RE: Florida Department of Environmental Protection Letter Dated April 2, 2007, DEP File Number 0930104-014-AC, Application No. 1270-2, Okeechobee Landfill Facility, Okeechobee Landfill, Inc.

RE: Florida Department of Environmental Protection Letter Dated April 2, 2007, DEP File Number 0930104-014-AC, Application No. 1270-2, Okeechobee Landfill Facility, Okeechobee Landfill, Inc.

On April 2, 2007, Okeechobee Landfill Inc. (OLI) received a request for information from the Florida Department of Environmental Protection (FDEP) in response to the permit application (DEP File Number 0930104-014-AC). Below is our response to that request.

ATTACHMENT 6
Average Annual Gas Potential Curve

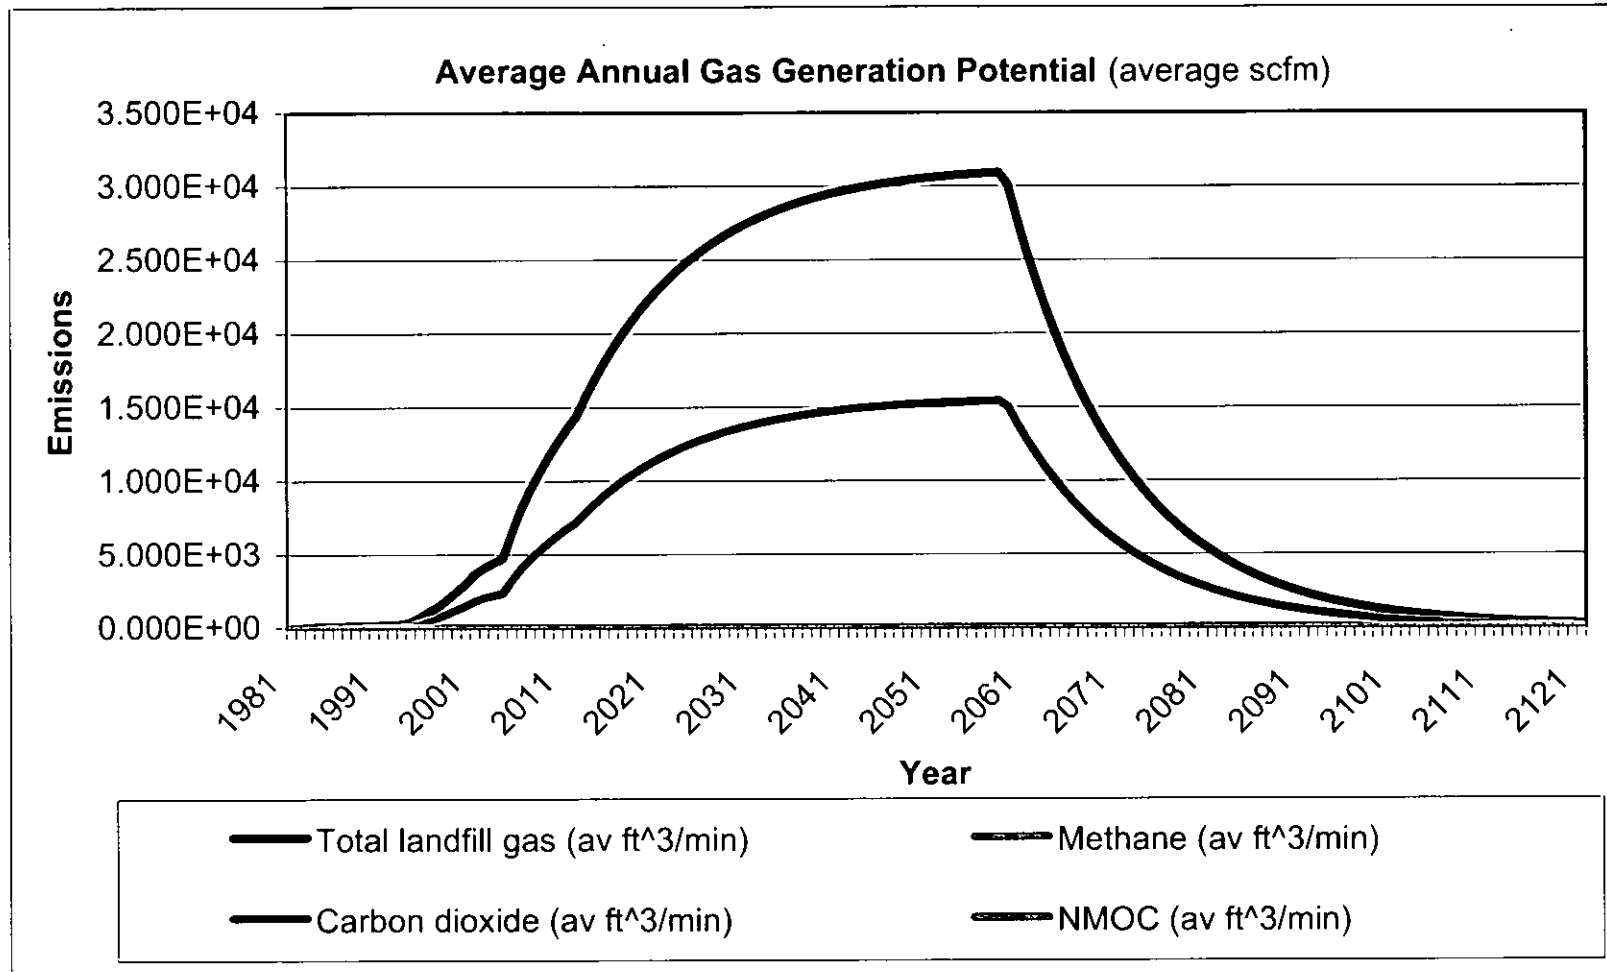
Comment No. 1: In the application the capacity of the landfills is mentioned in the Support Documentation Section II., subsection 3.3.1. and in Appendix E, LFG (Landfill Gas) Generation Rates & Construction Schedule. The landfill capacity is important in defining the potential to emit for the facility. While on-site and as mentioned in the application, two solid waste permits apparently exist for the existing site and the proposed new site. The solid waste permits referenced are Permit Number 0040842-010-SC for the Berman Road Landfill site and Permit Number 0247963-001-SC for the Clay Farms Landfill site.

- a. In Appendix E, the memorandum indicates the capacity of each landfill was estimated by Okeechobee Landfill, Inc. to be 23,431,195 tons for the Berman Road Landfill and 119,324,195 tons for the Clay Farms Landfill. One ton of waste was assumed to be equivalent to one cubic yard. Together these two sites occupy approximately 4,300 acres. Please provide a copy of the pertinent page(s) of these solid waste permits and relevant documentation to support the cited "permitted solid waste capacities."
- b. Please provide landfill gas generation graphs for the Berman Road and Clay Farms sites, with landfill gas flow (scfm) plotted versus years.

- a. The entire property consists of 4,150 acres (corrected from the 4,300 estimate); however, the permitted solid waste disposal footprint is only 833 acres of the total property acreage. **Attachment 5** includes copies of the permit pages with the stated acreage.
- b. A landfill gas generation potential curve is at **Attachment 6** of this letter. Please note the Berman Road and Clay Farm areas are not separate stationary sources. Clay Farms is not a proposed new site, but a permitted capacity increase of the existing stationary source. The nomenclature is used to distinguish the areas.
